Z-27
(2014)

ZONING PLAN EOR:

PETITION NO: Z-27

ZONING COMMENTS:

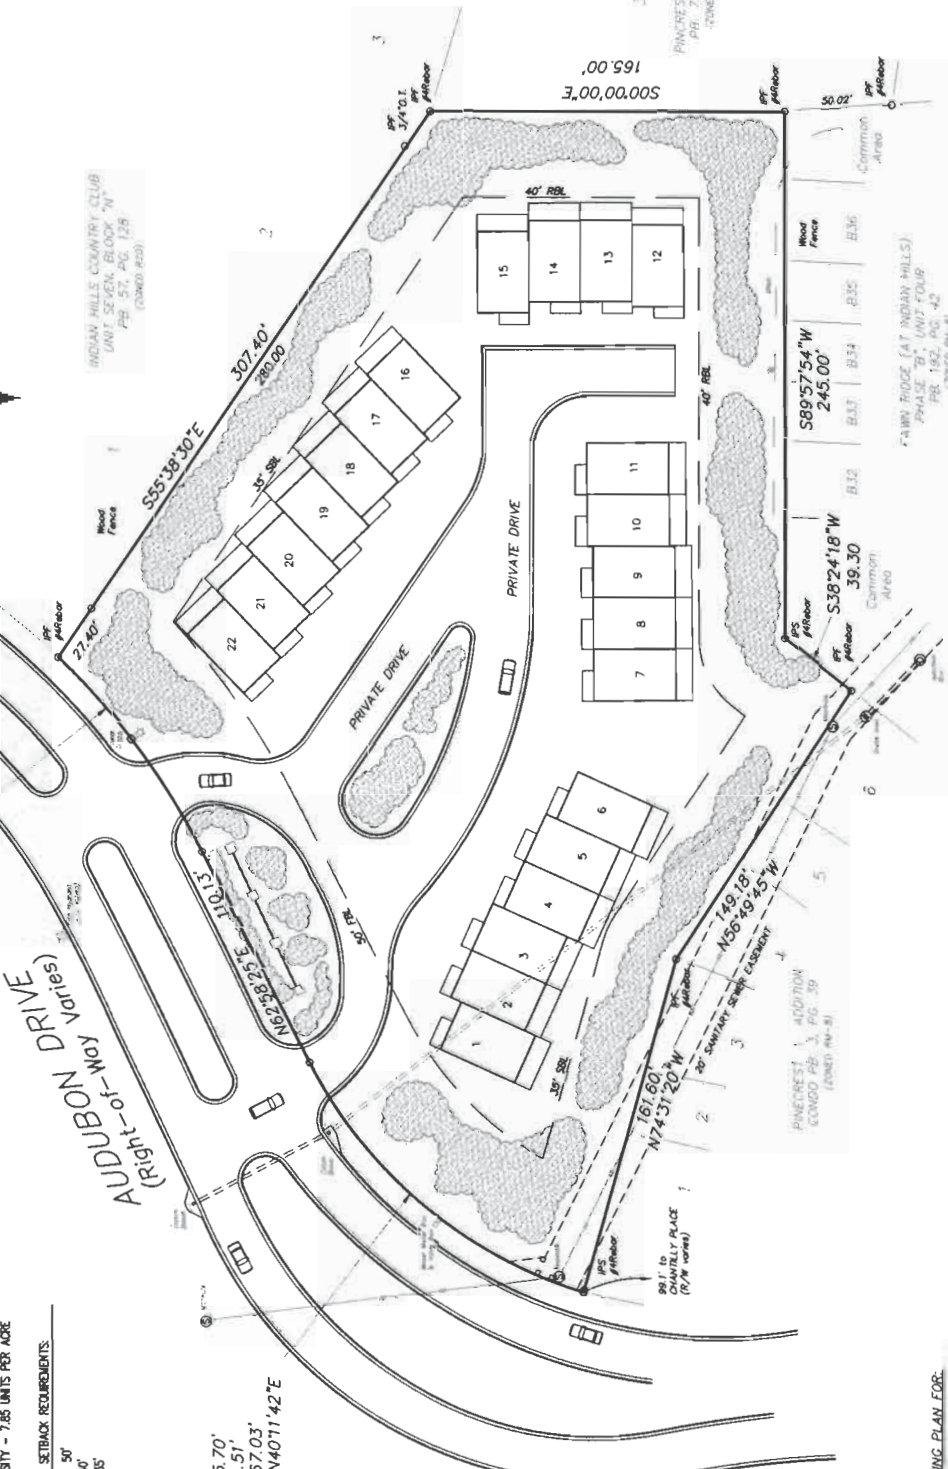
There is a required 25-foot landscape buffer required along the north property that is not shown.

GUEST PARKING: When projects contemplate less than 20 foot separation between units, guest parking shall be provided or the streets shall be labeled as a fire lane.

- No Stormwater controls shown _____
- Copy of survey is not current – Additional comments may be forthcoming when current site conditions are exposed.
- No site improvements showing on exhibit.

Recommend curb and gutter along both sides and sidewalk along one side of proposed development roadway.

Recommend sidewalk along the Audubon Drive frontage.

Recommend applicant verify that minimum intersection sight distance is available for ingress and egress maneuvers for the site if it is not, implement remedial measures, subject to the Department's approval, to achieve the minimum requirement of 280'.

- Maximum of 5 units per acre, which yields 14 lots;
- 25 foot landscape buffer be installed along the north property line adjacent to the R-20 zoned properties;
- Final site plan be approved by the District Commissioner;
- Fire Department comments and recommendations;
- Water and Sewer Division comments and recommendations;
- Stormwater Management Division comments and recommendations;
- Department of Transportation comments and recommendations.
